Project
Residence for Mr.
JAYAKUMAR

Drawing Title
GROUND FLOOR PLAN-R2

Drawing Title
FIRST FLOOR PLAN-R2

Drawing Title
TERRACE FLOOR PLAN-R2

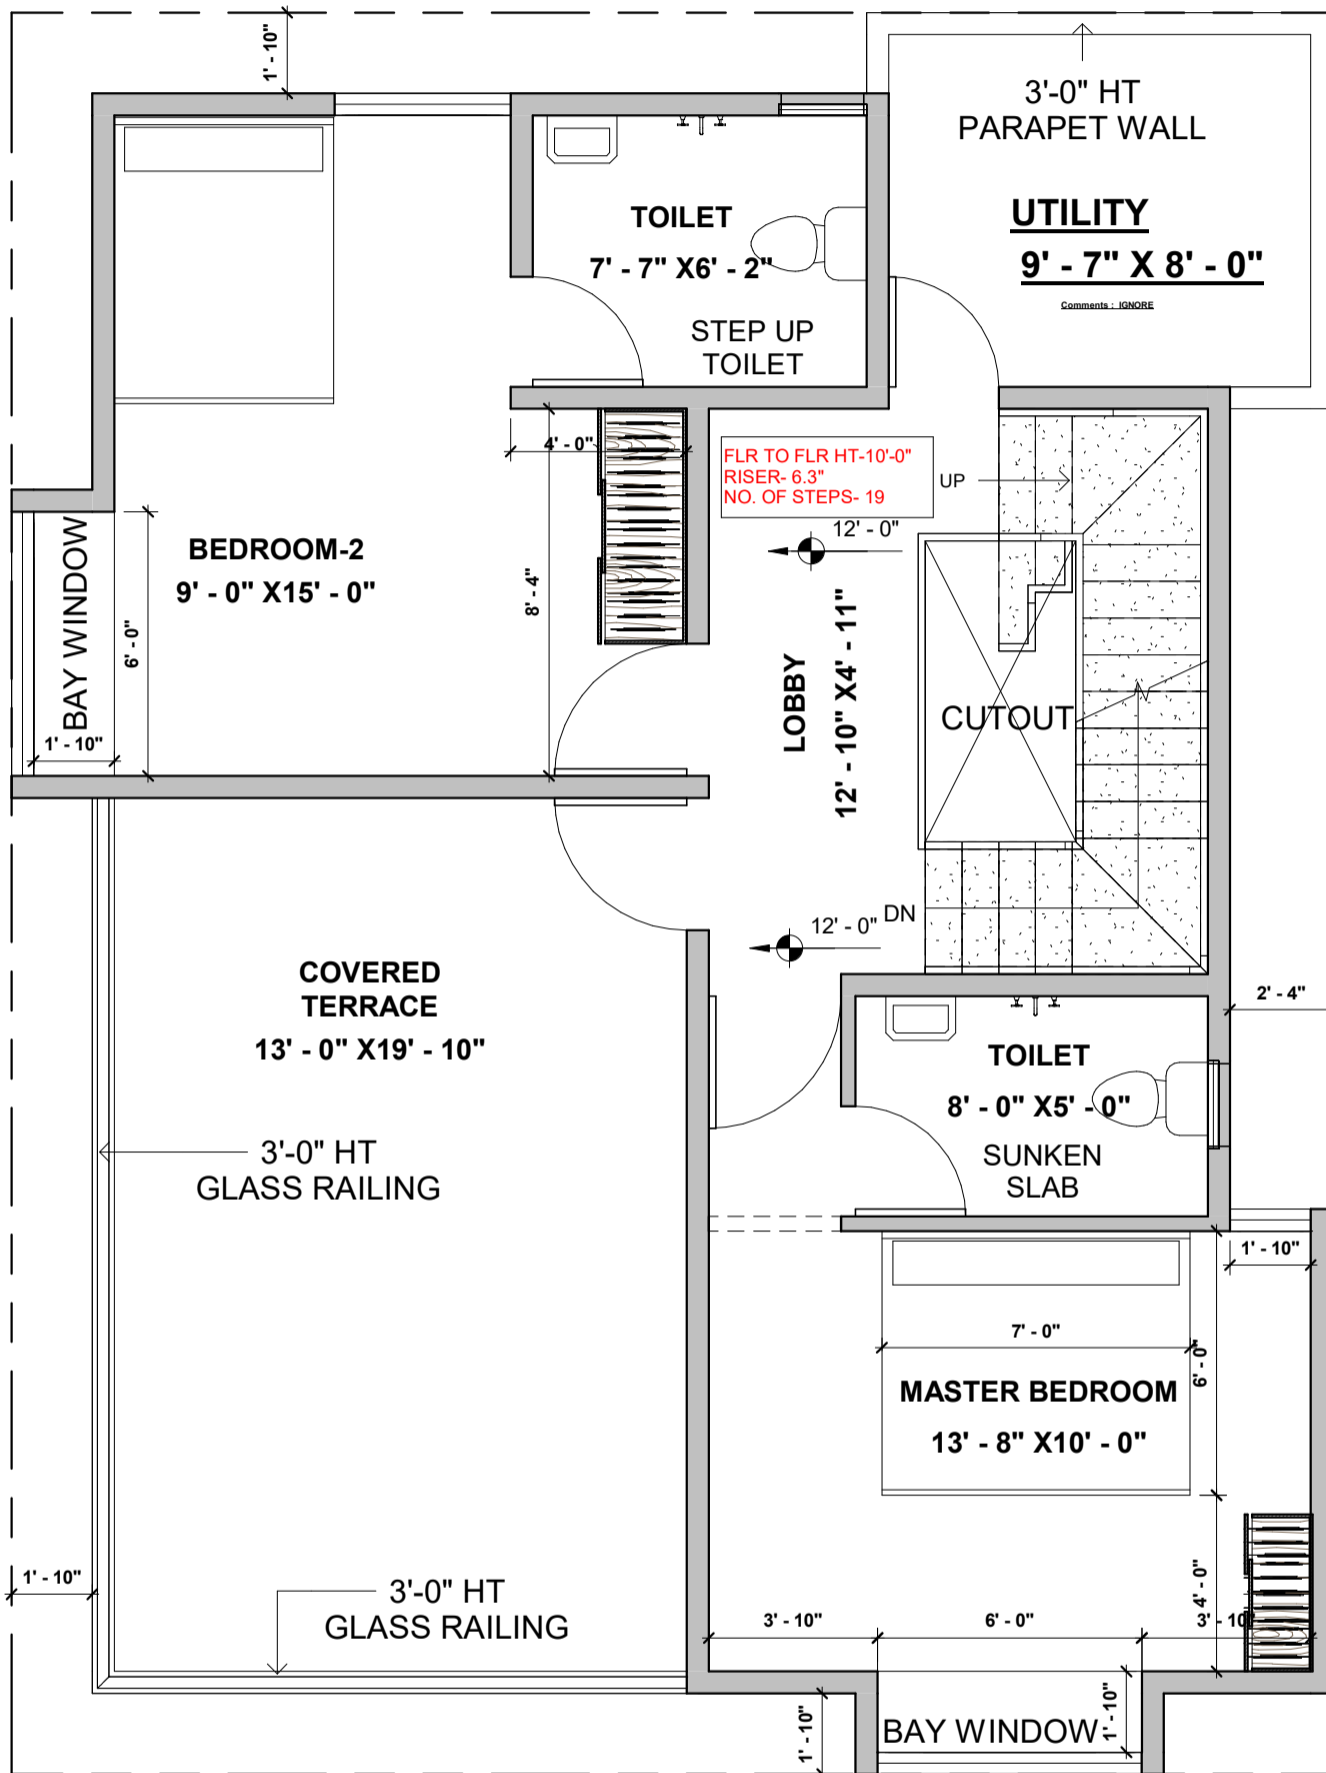
R1- GROUND FLOOR PLAN
 1. POOJA DIMENSION
 2. WINDOW CHANGES AS PER CLIENT REQUIREMENT
 3. UTILITY INCREASED UPTO COMPOUND WALL IN EAST DIRECTION
 4. LIVING- DOUBLE HEIGHT

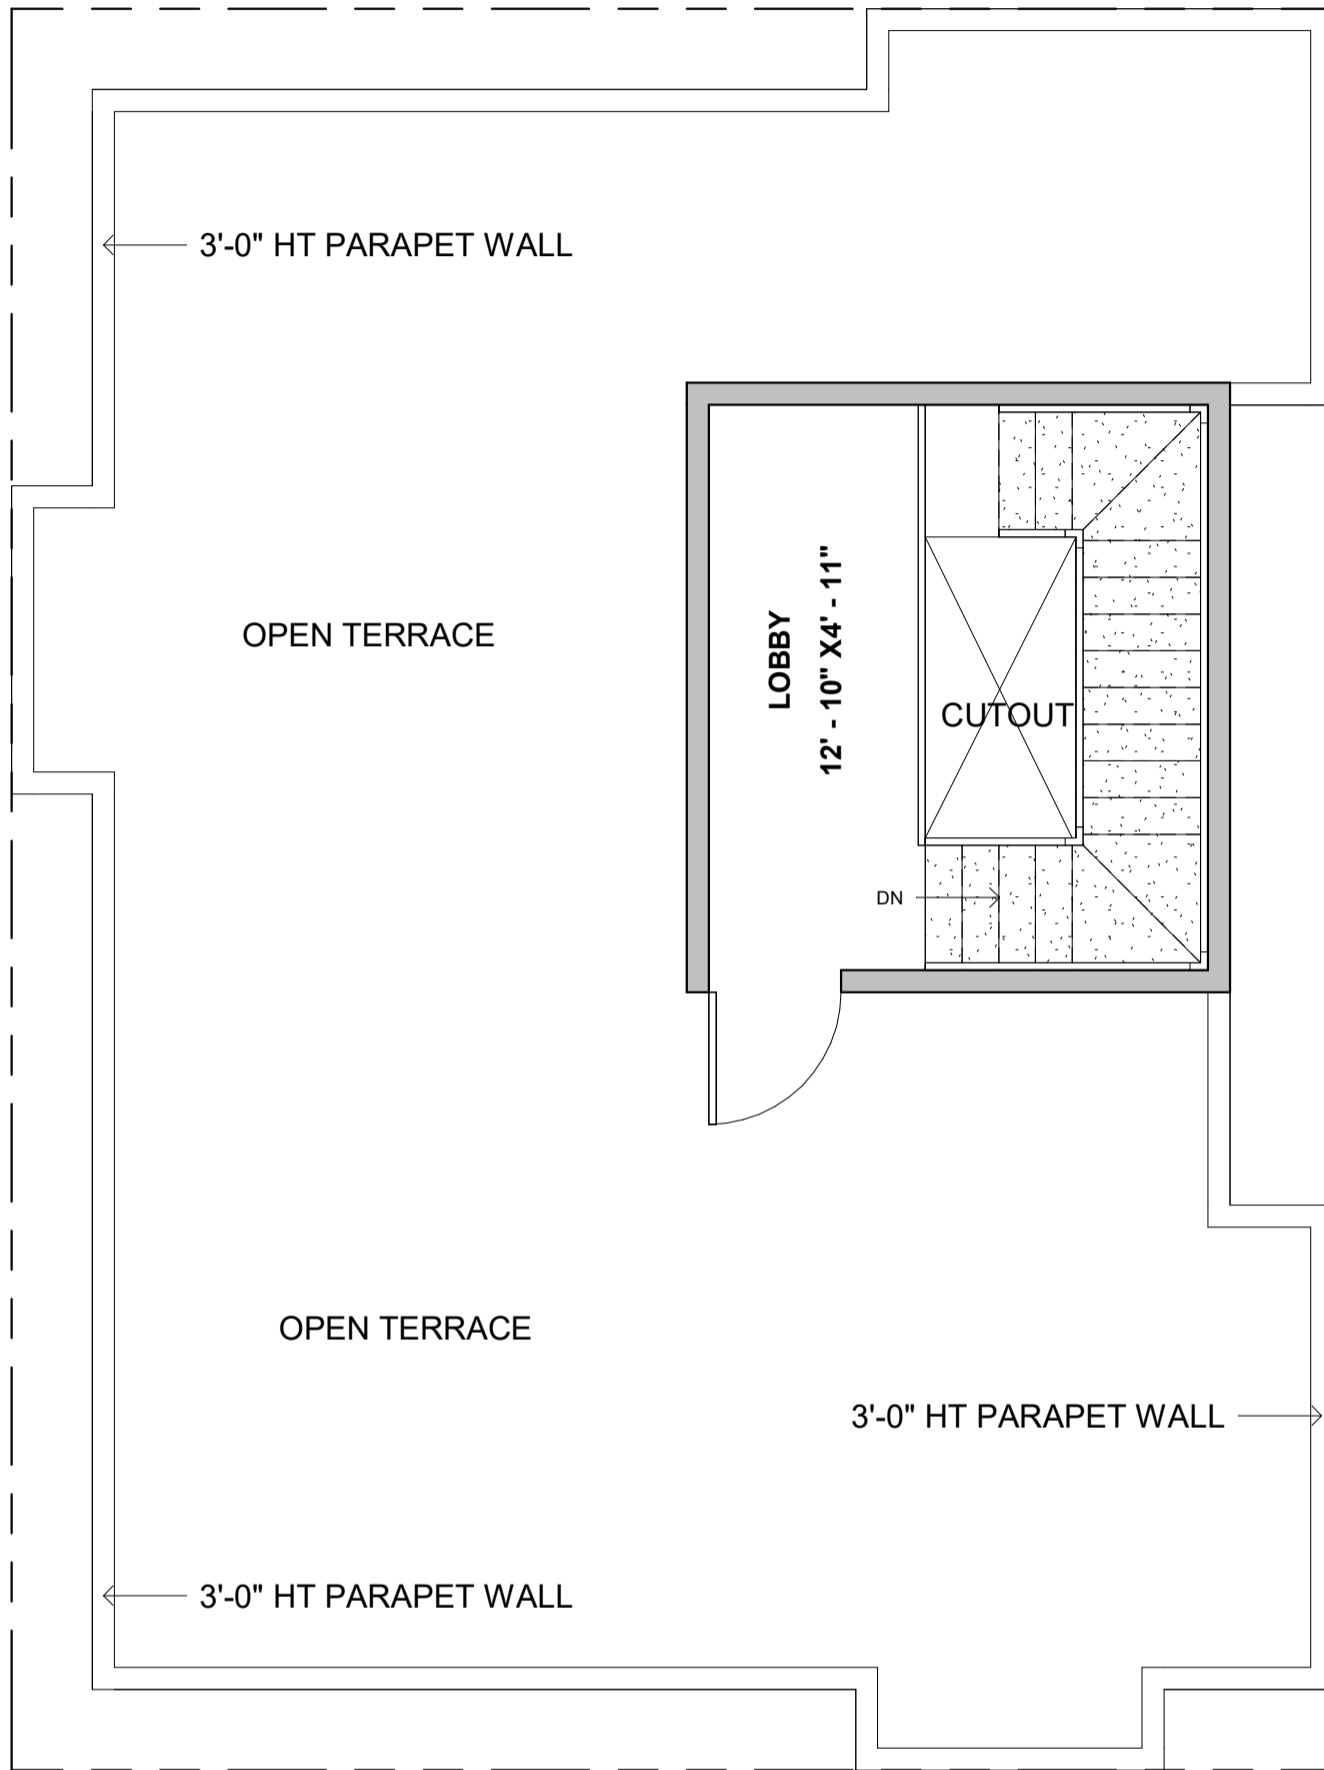
- FIRST FLOOR PLAN**
1. EXTENSION REDUCED IN WEST AND NORTH DIRECTION
 2. UTILITY INCREASED AS PER GROUND FLOOR UTILITY.

- R2**
- FIRST FLOOR PLAN**
1. OPEN TERRACE INCLUDED
 2. BAY WINDOW ADDED
